Access Compliance Report Public Rights-of-Way (Curb Ramps)

Main Street: 17TH_ST Cross Street: HEWES_AVE Location: S

ADA ID: RPRK211008123423 Ramp Type: Type 1 - Perpendicular Initial Pass/Fail: Fail Overall Compliance: No Severity Score: 15

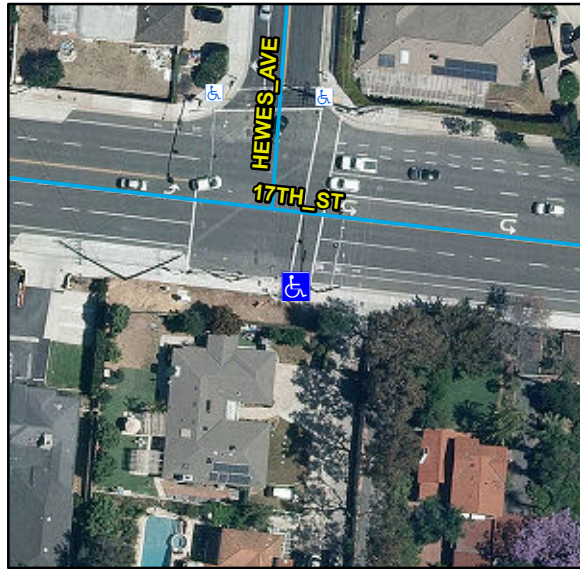
Remove & Replace Entire Ramp.

R304.2.2, STD 1115
